**CONTRACT NO: FACD08 RESTROOMS AT PREBLE TRUCK PARKING
PROJECT: DOT-250005**

ADDENDUM NUMBER TWO (2)

FACD08 Restrooms at Preble Truck Parking
Ohio Department of Transportation (ODOT)
I-70 WB @ MM 01, New Paris, Ohio 45347
Preble County

SHEET
C.101

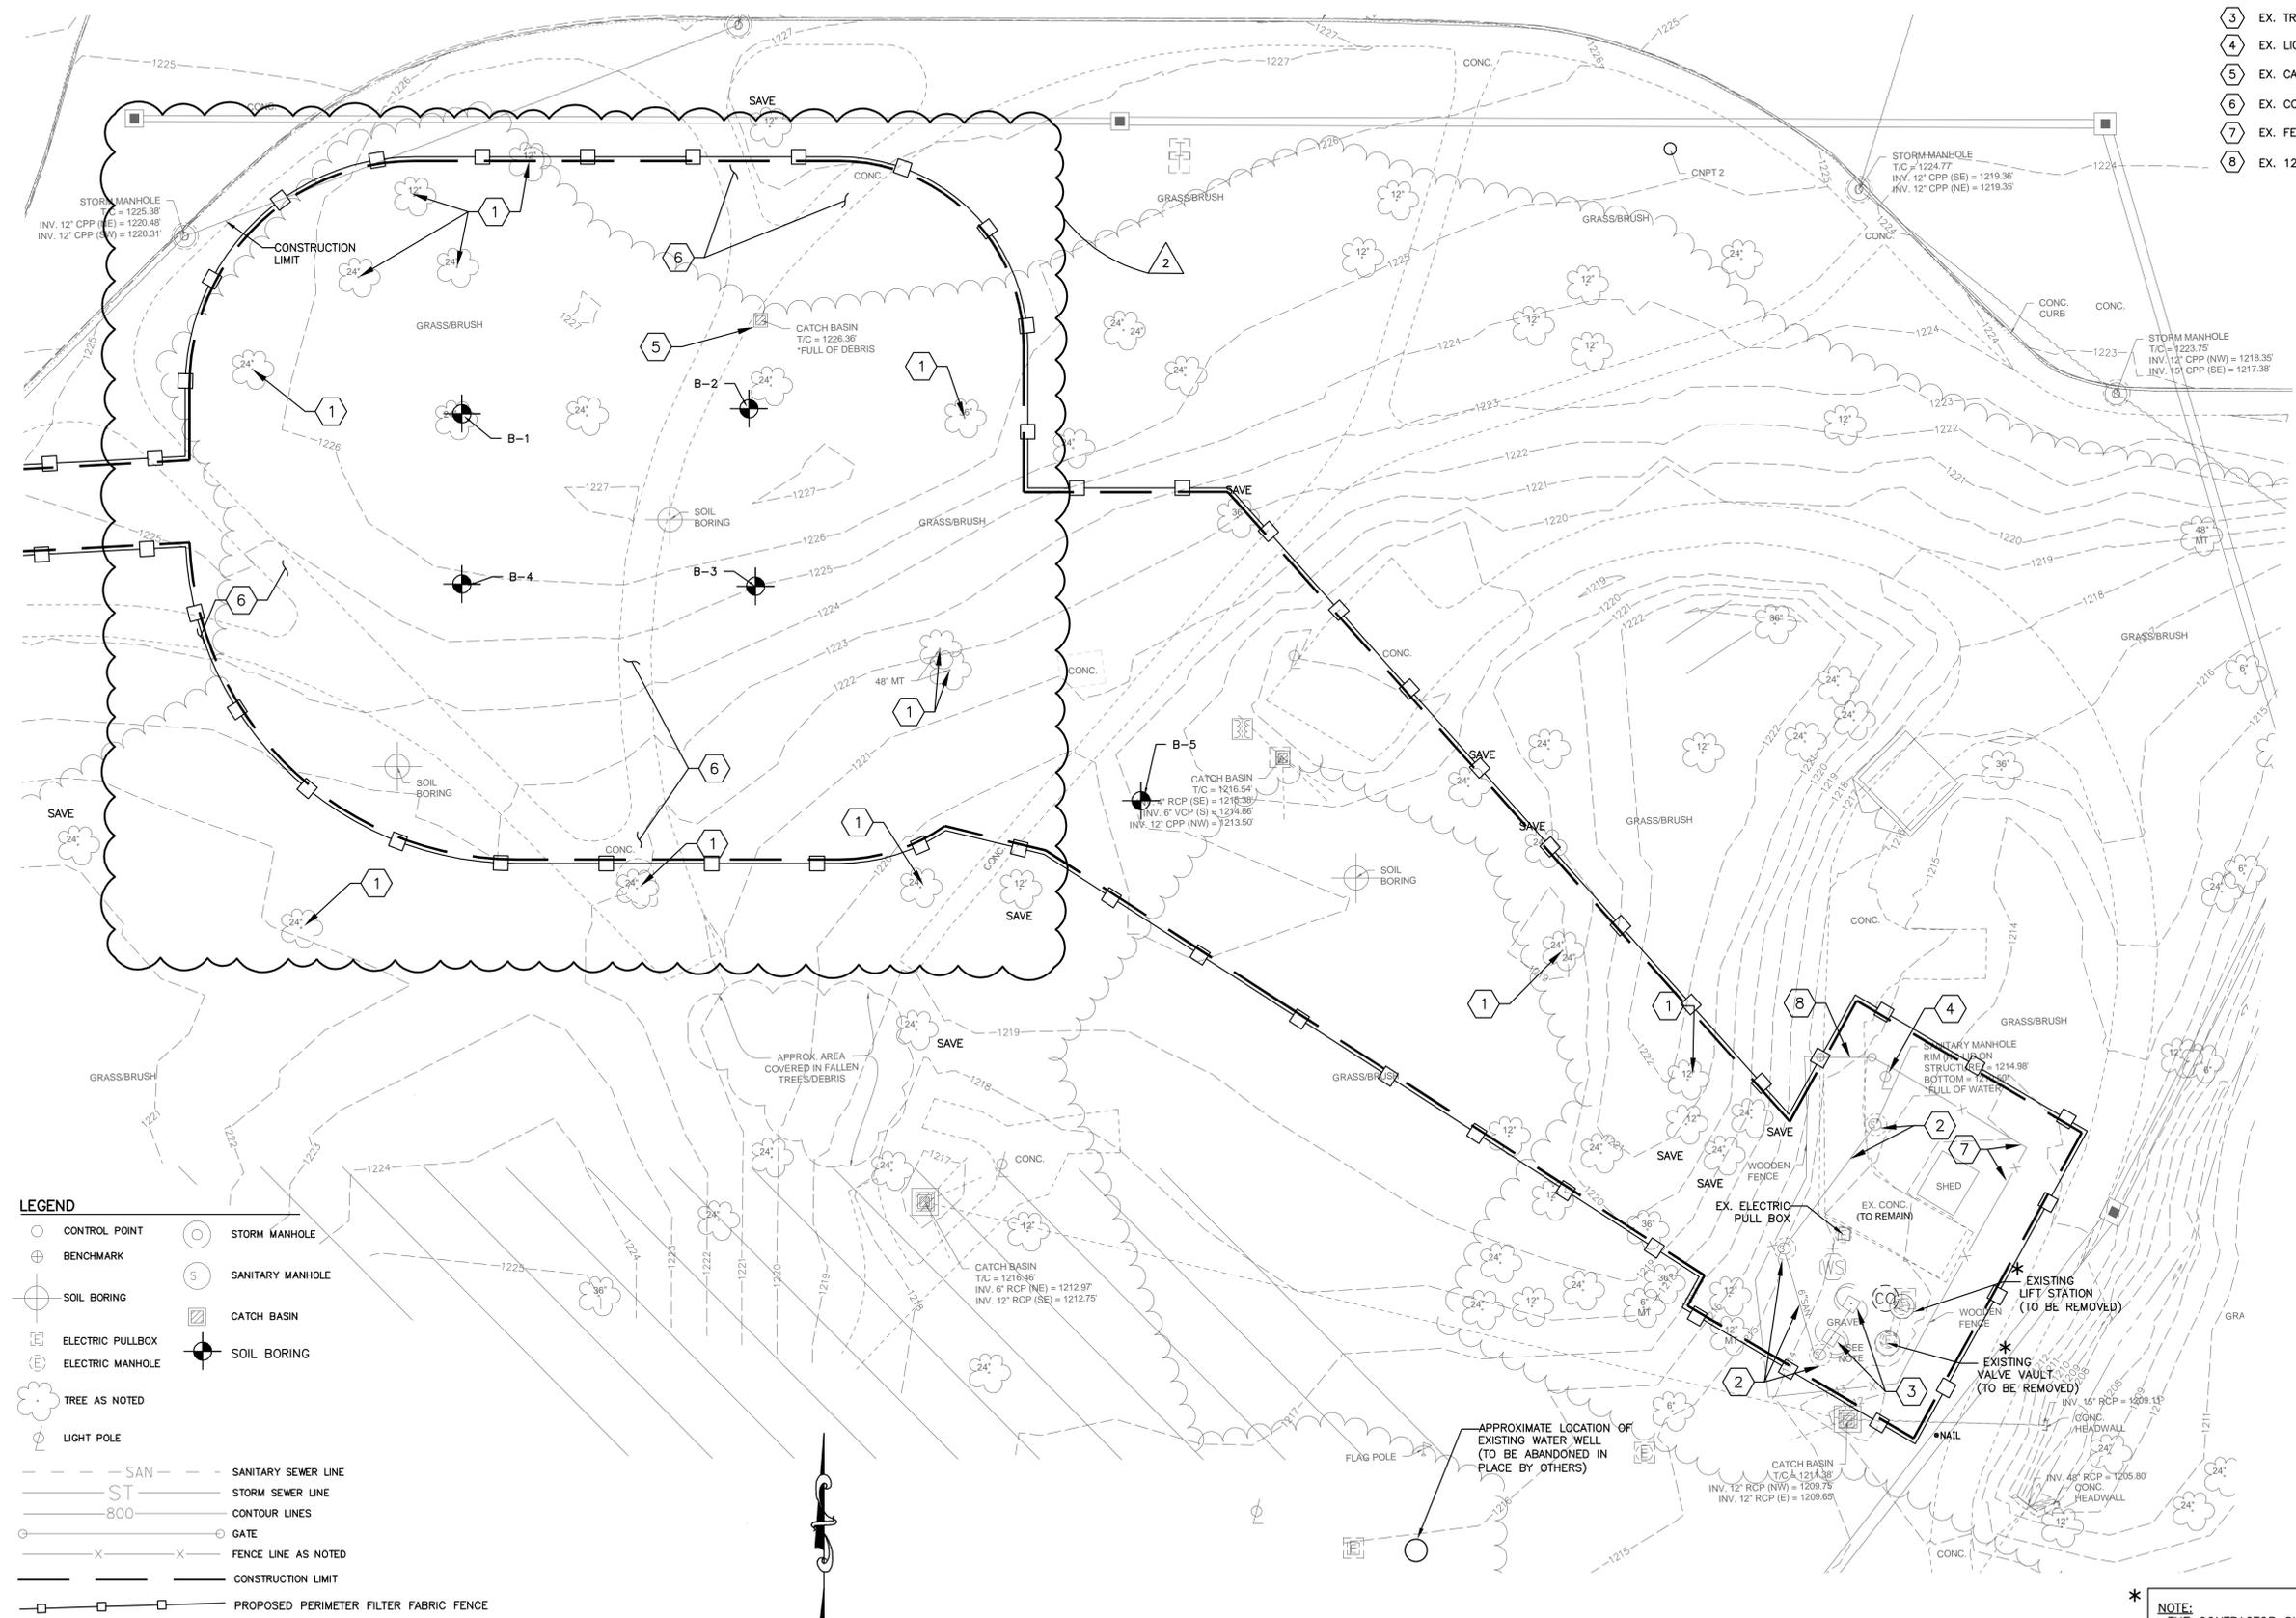
D-02. C.101 has been revised to show existing sidewalk

RFI-12: What are the extents of the concrete sidewalk removal? Can square footage and depth be provided?

Response: SEE UPDATED SHEET C.101

SHEET
C.102

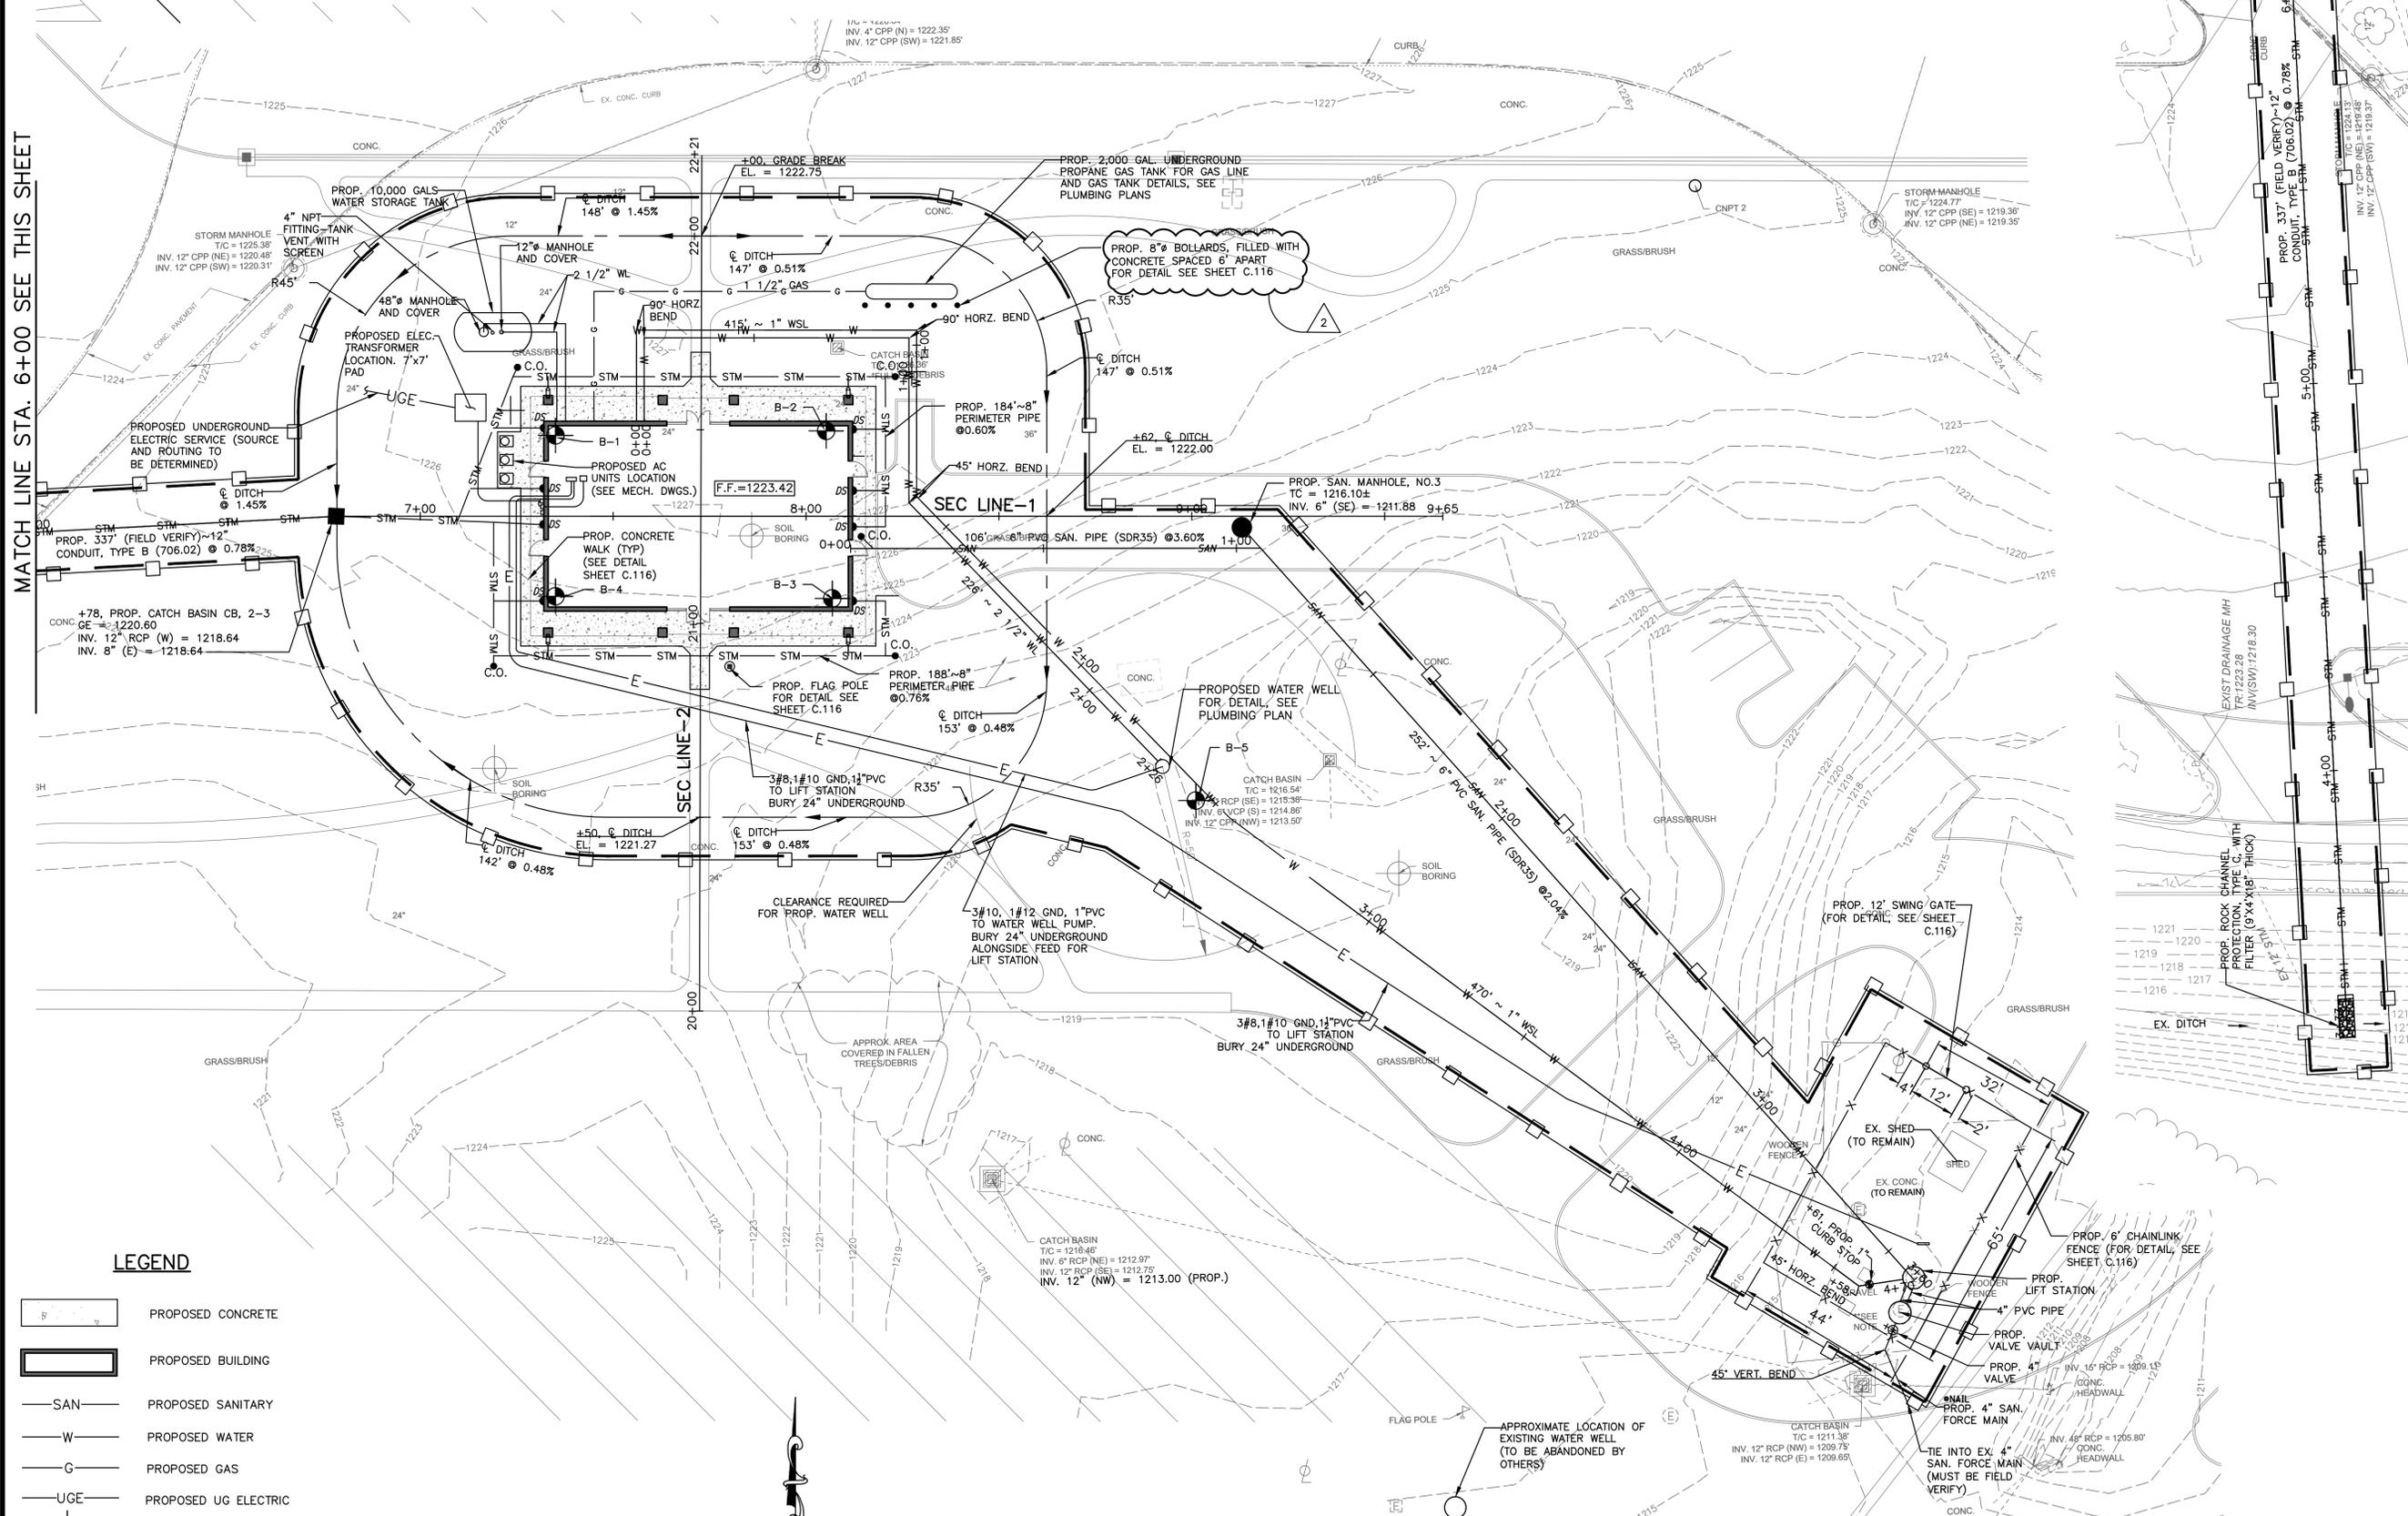
D-03. C.102 has been revised to show correct bollard sizing

RFI-13: C102 shows 6" bollards, but C116 shows 8" bollards. Which is the correct size?

Response: Size is 8" for bollards

SHEET
G.002

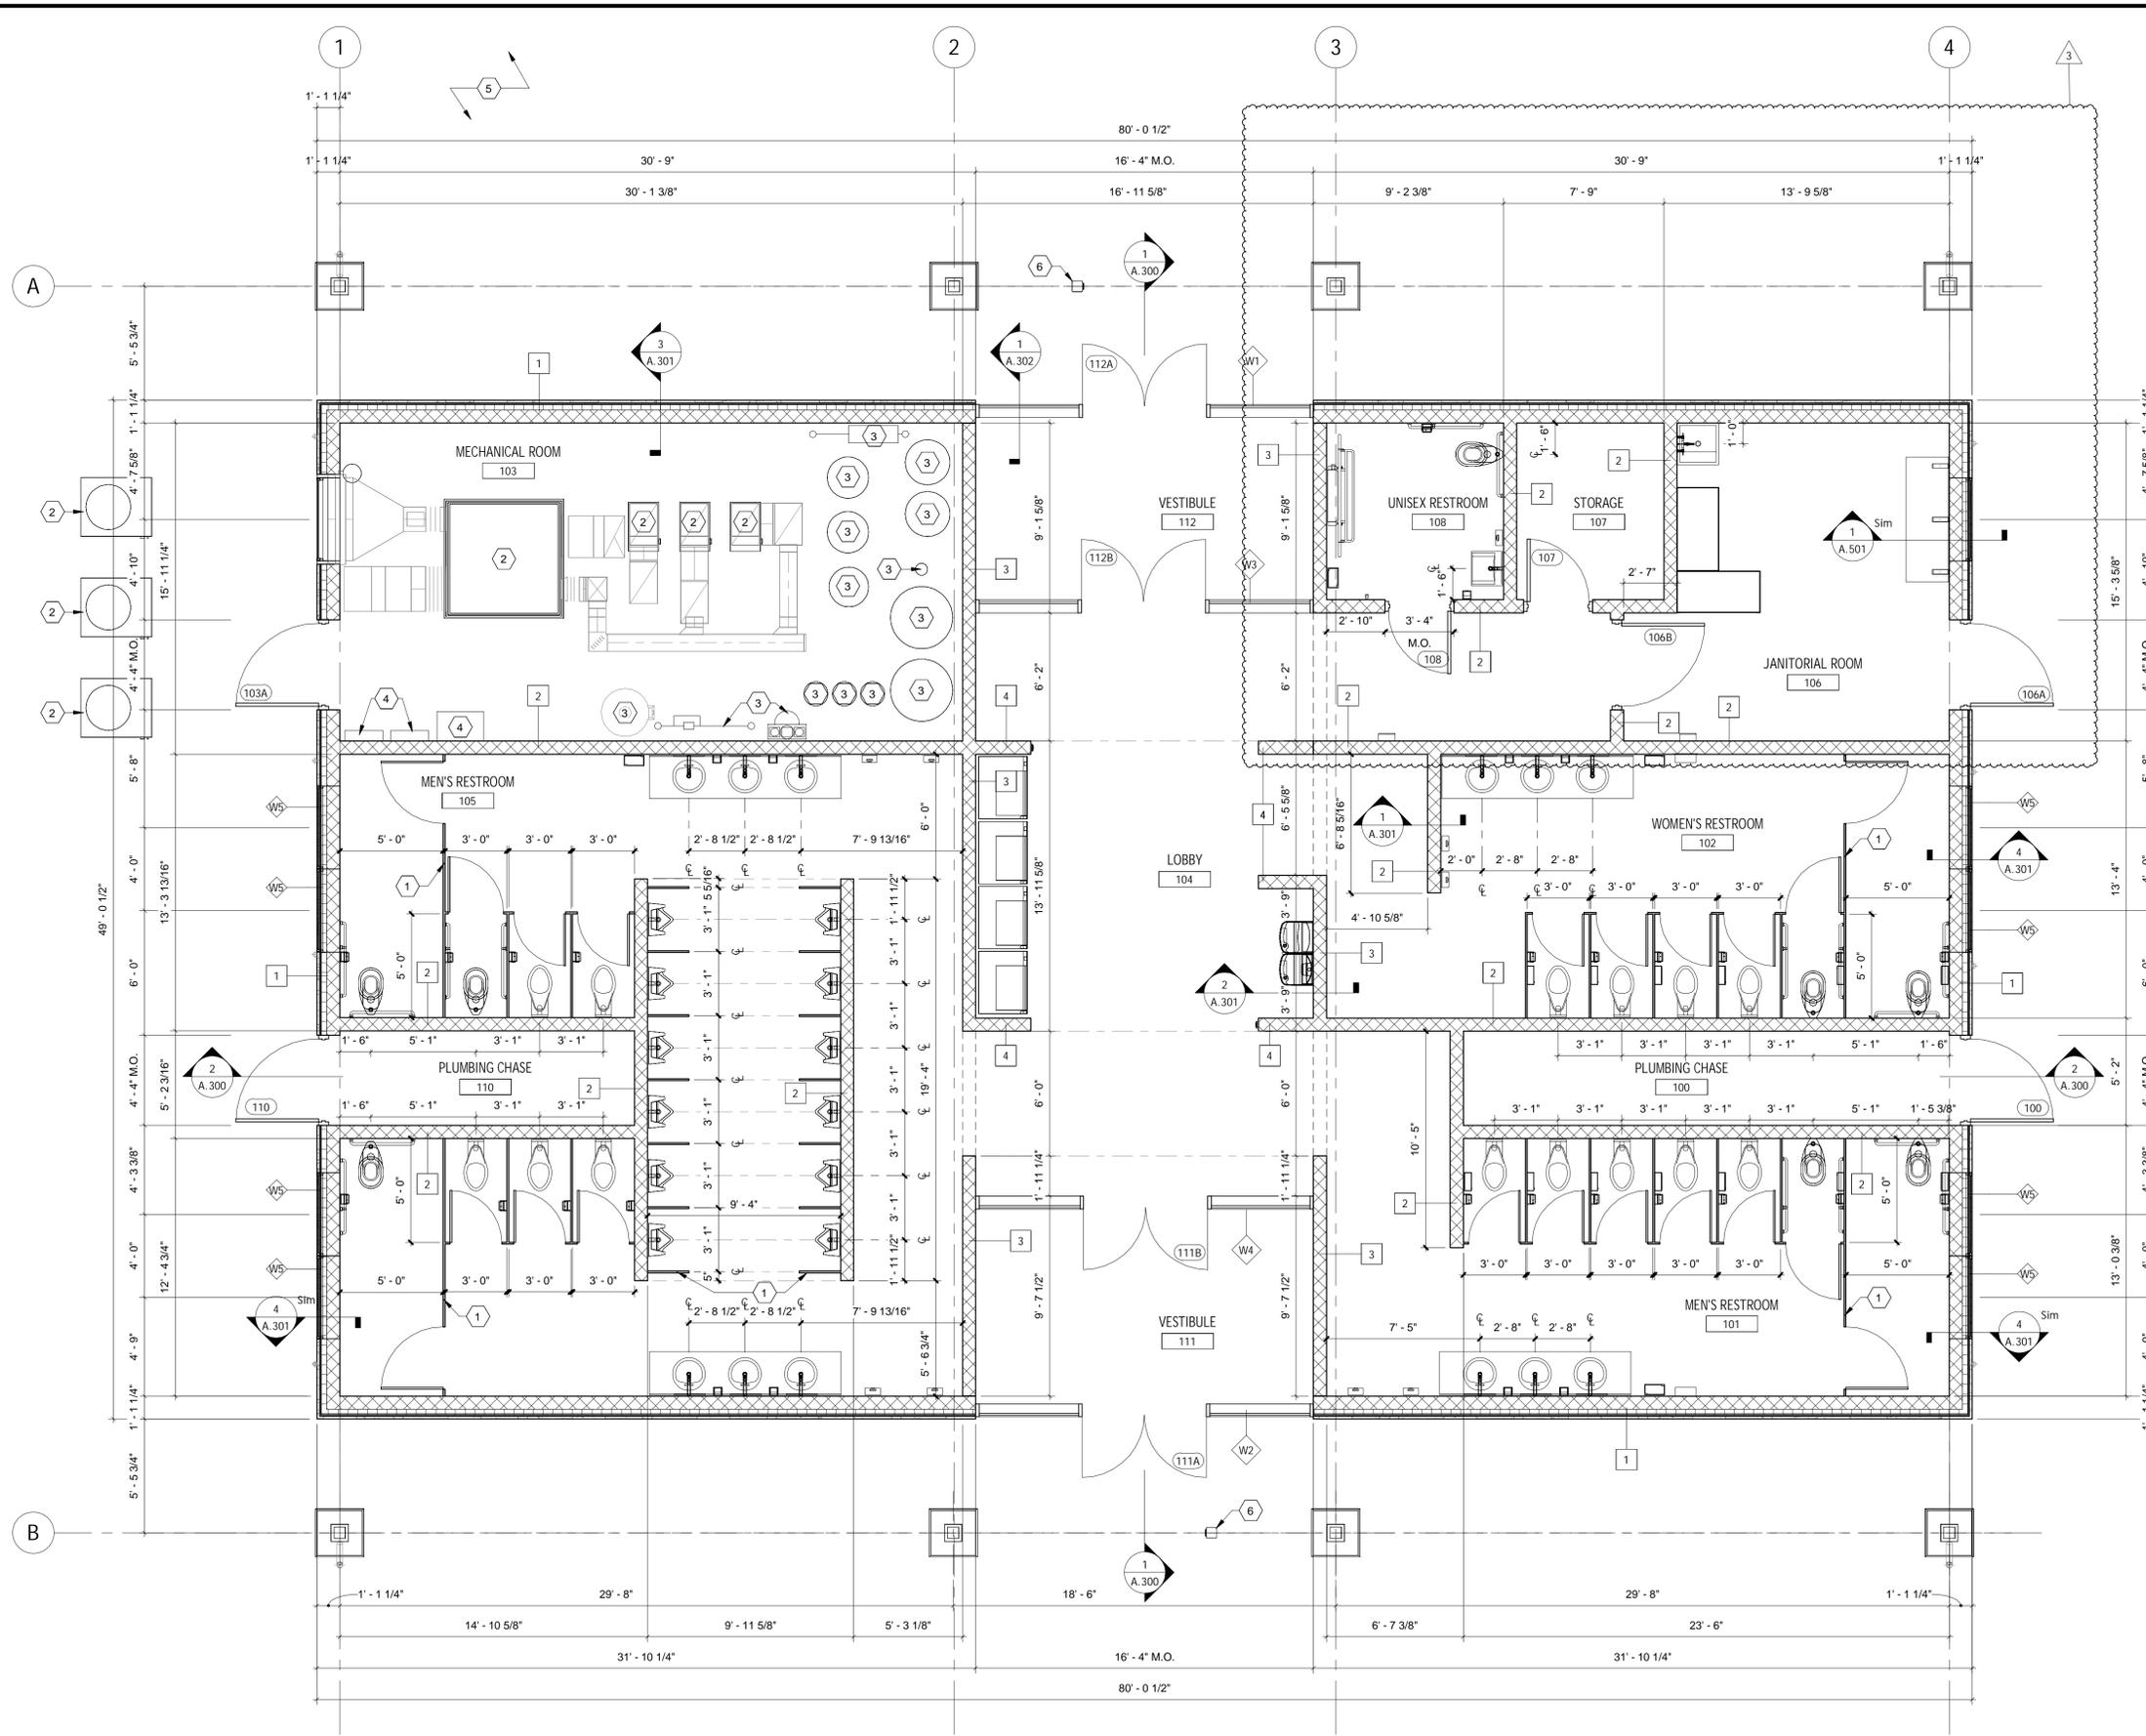
D-01. G.002, A.101, A.102, A.400, A.600 have been revised to allow space for adult changing station in Unisex Restroom 108
